PLANNING & ZONING COMMISSION

Wednesday, May 18, 2022, 10:00 AM

- B. **Request for Site Plan; Bristol Park Apartments** (Project Name); 19510 US 4541(Site Address) Limit Ave (South) US Hwy 441 (North East) (Location); Cagan Management Group, Inc. (Applicant); Wicks Engineering Services, Inc. (Engineer); L.R. Huffstetler, Inc. (Landscape Architect); Forum Architecture & Interior Design (Architect). Project No. SP22-03.

BRISTOL PARK APARTMENTS
 COVER SHEET
 MOUNT DORA, FLORIDA 34736

C:\Users\Bilin\Documents\Work\Jobs\Wicks\jobs\19123 Bristol 2022\plans\19123 Total.dwg, Sht 12 Plan Profile Street A, 4/13/2022 2:29:47 PM

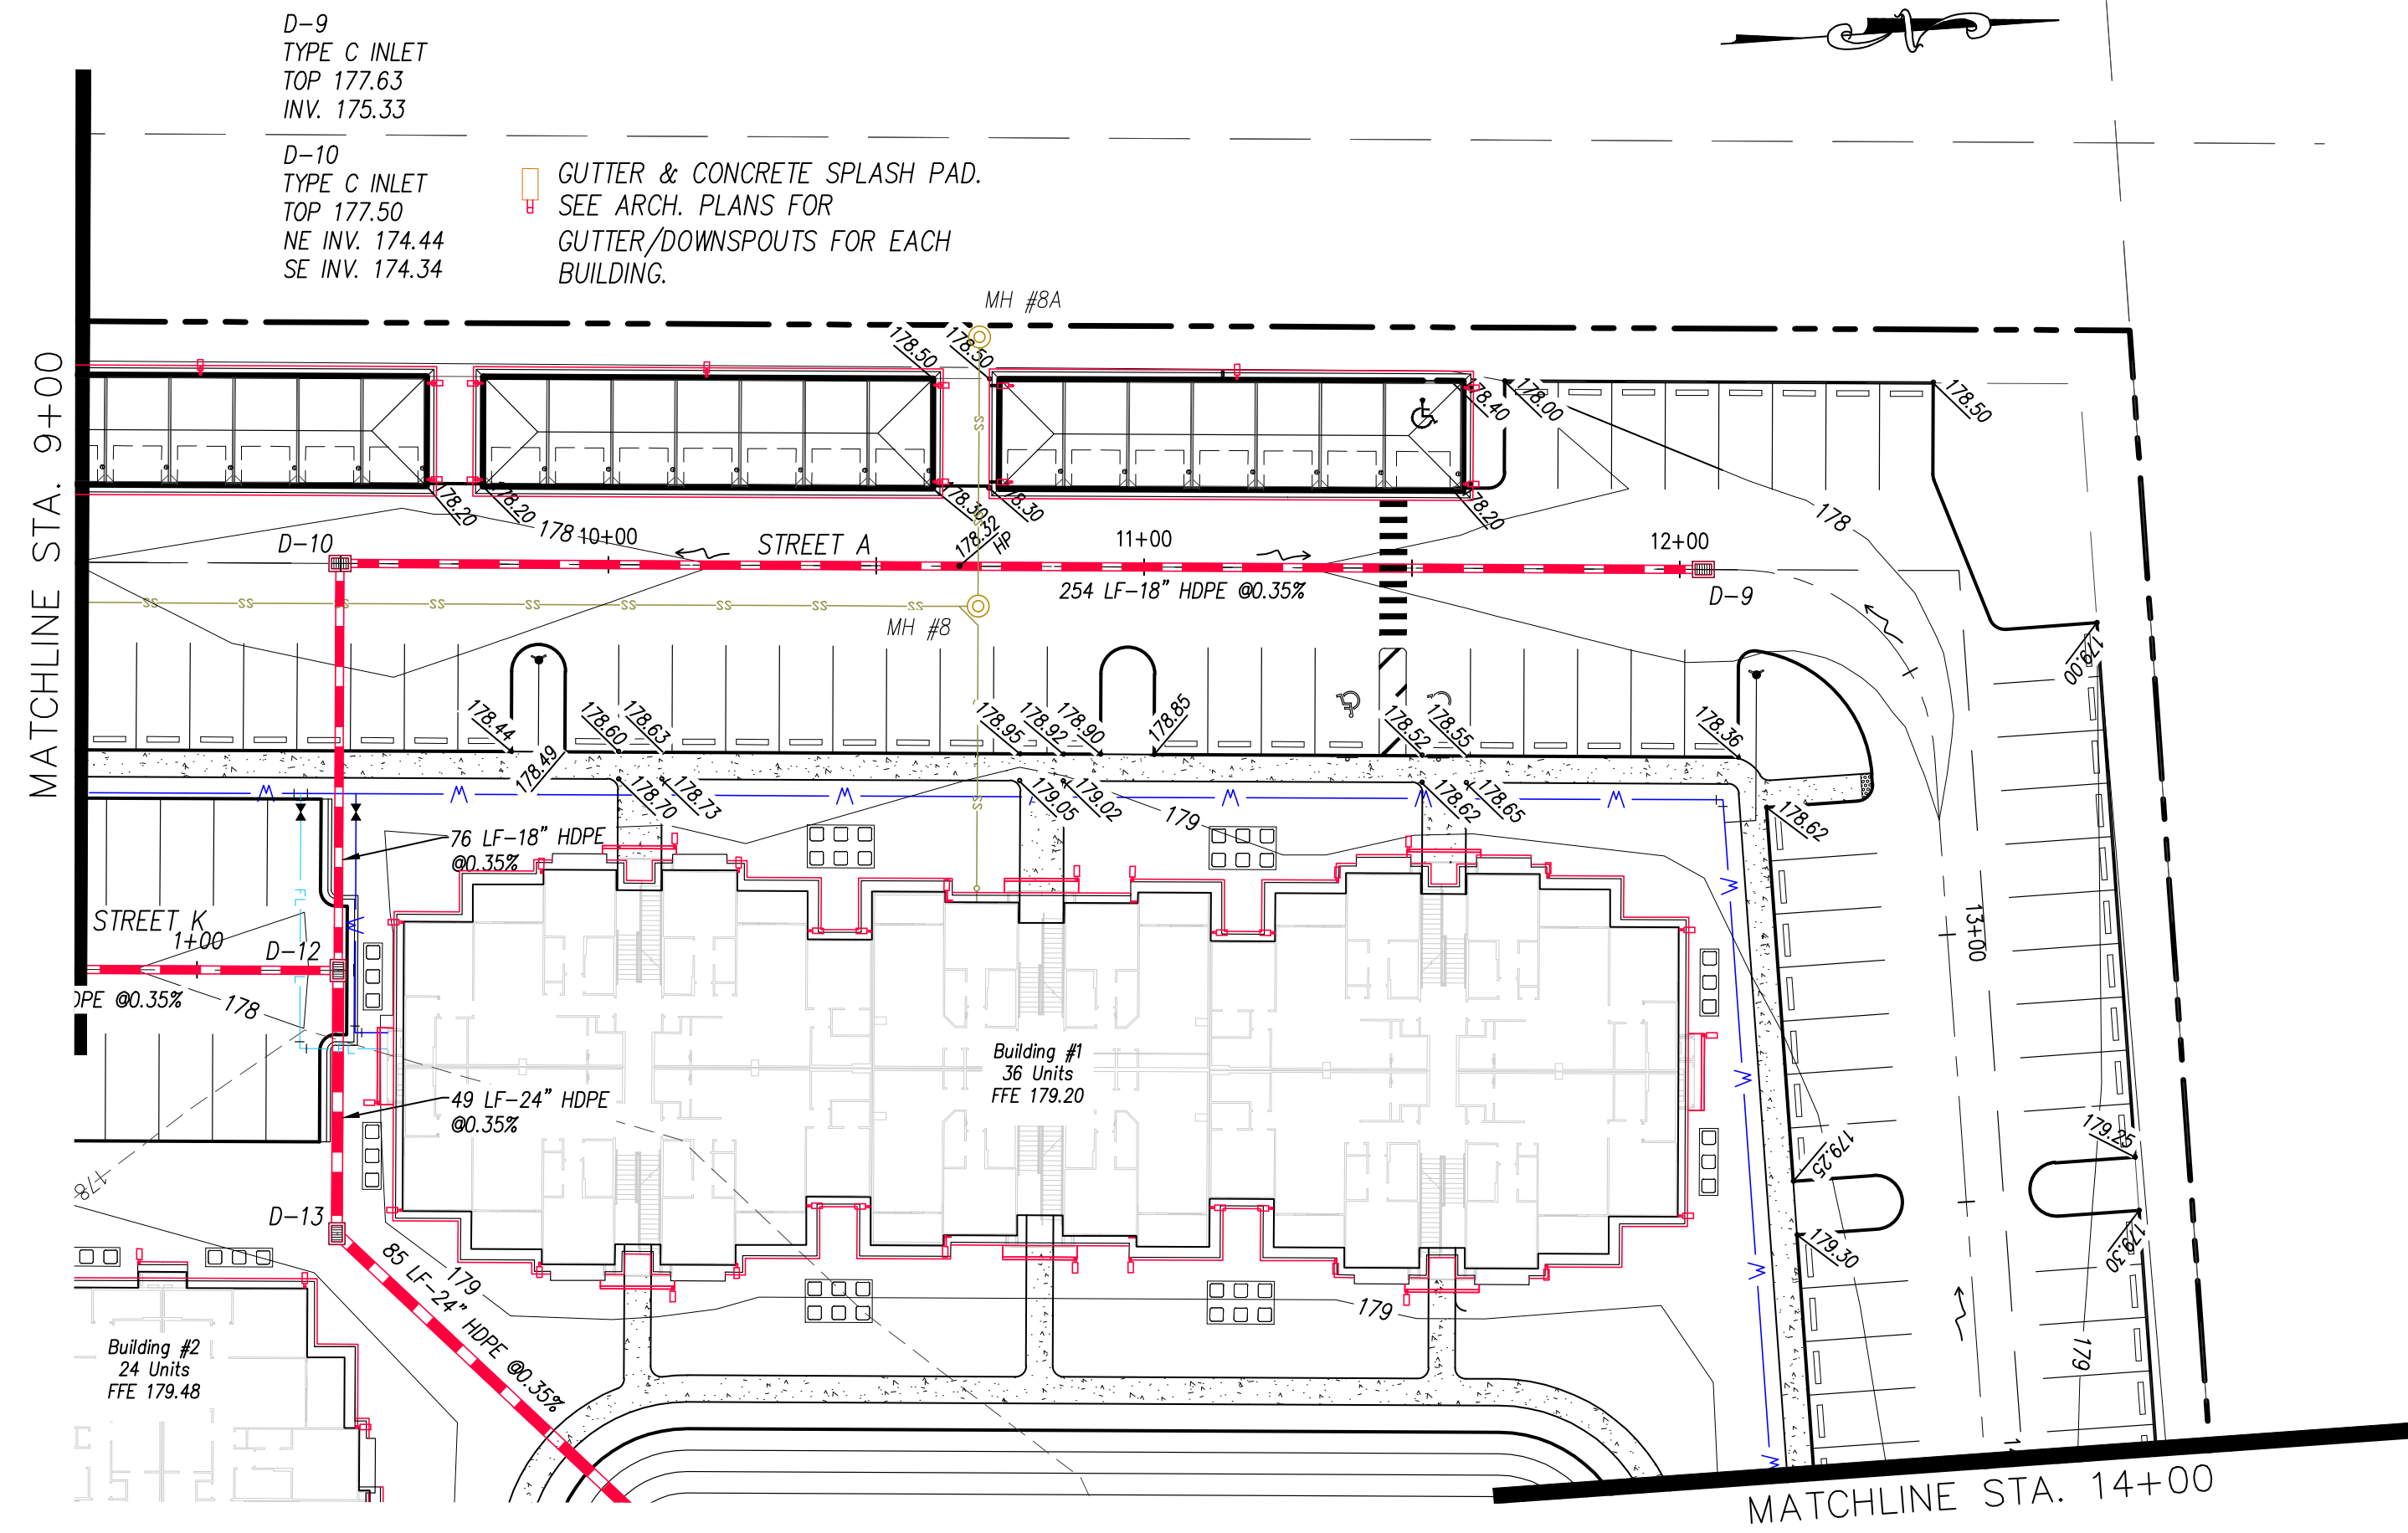
32. Resolved
33. Sheet 10 of 26 – now sheet 12 - storm structure D-9 is only 2.3 feet deep and has an 18-inch pipe connected to it and D-10 is only 3.16 feet deep with an 18-inch pipe connected to it. The storm pipe will be into the base or subbase of the drive aisle. **Repeat comment**

C:\Users\Bliln\Documents\Work\Jobs\Wicks\19123 Bristol 2022\plans\19123 Total.dwg, Sht 14 Plan Profile Street B, 4/13/2022 2:30:36 PM

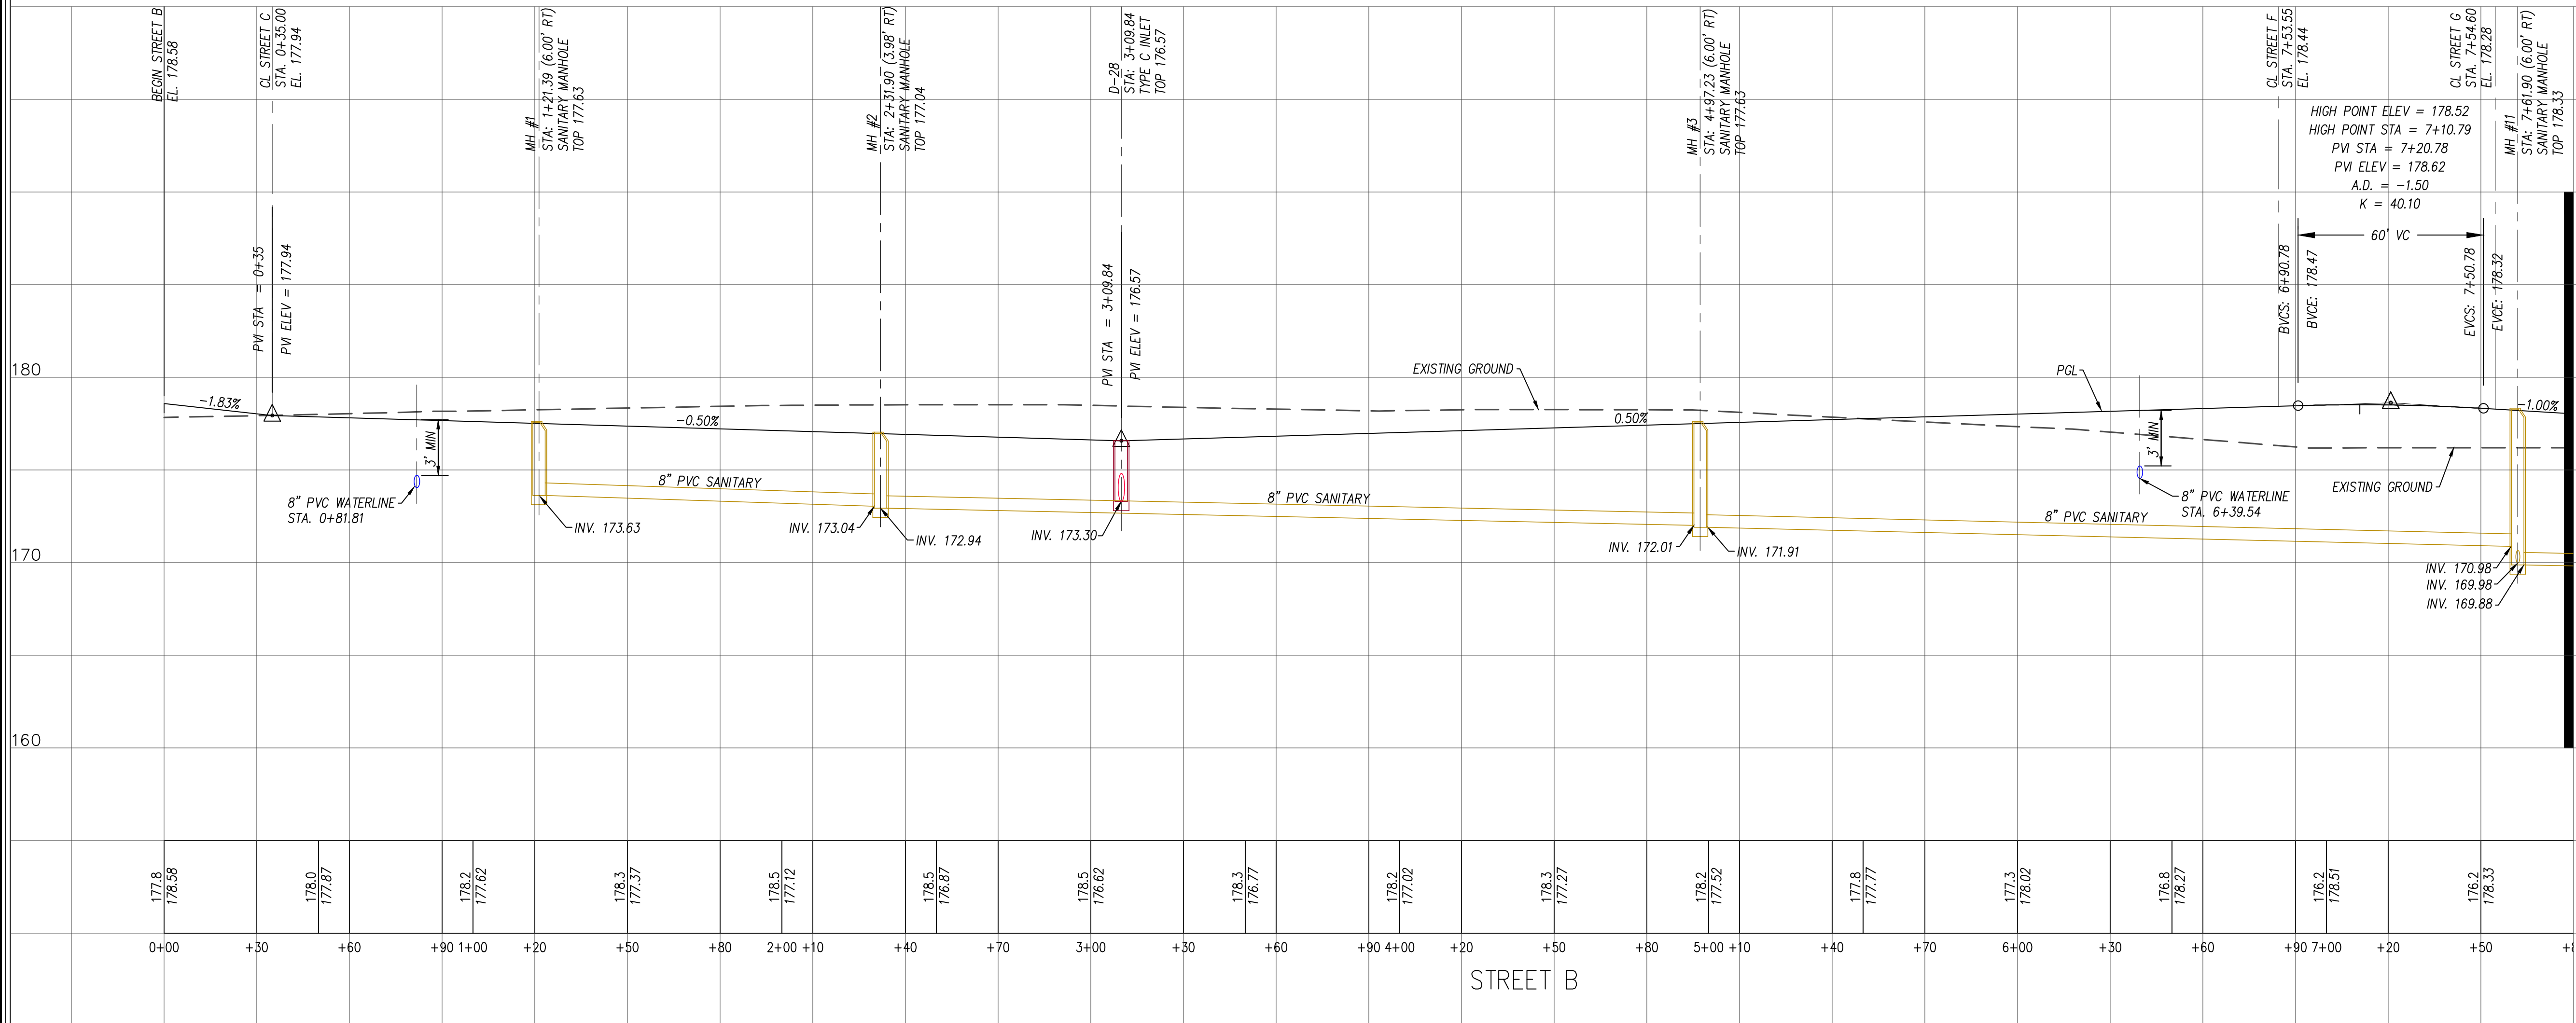
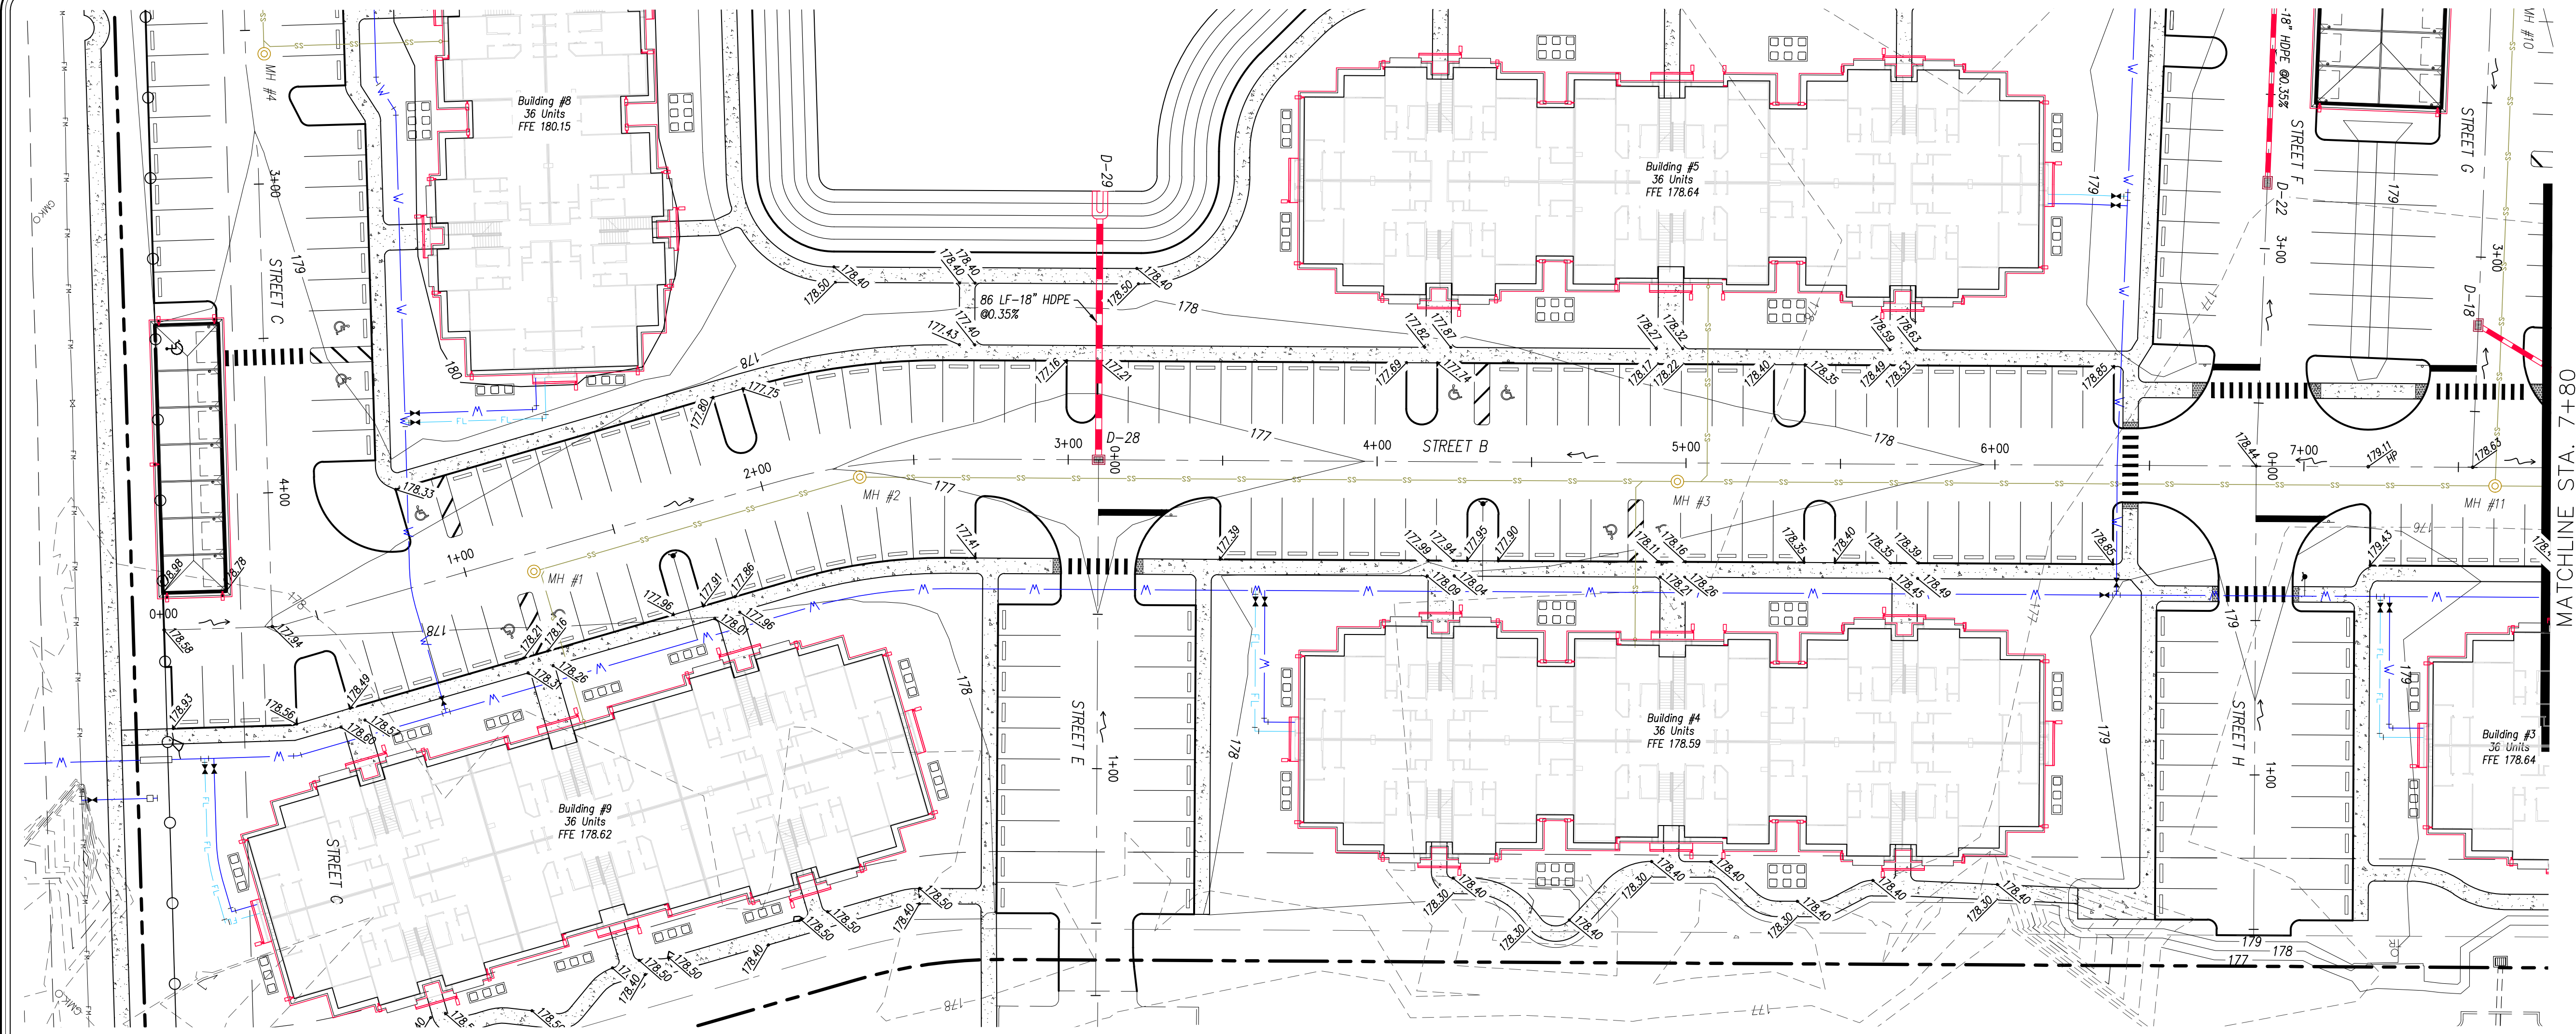
35. Sheet 11 of 26 – now sheet 14 - storm structure D-28 is only 3.27 feet deep with an 18-inch pipe connected to it. The storm pipe will be into the subbase of the drive aisle. **Repeat Comment**
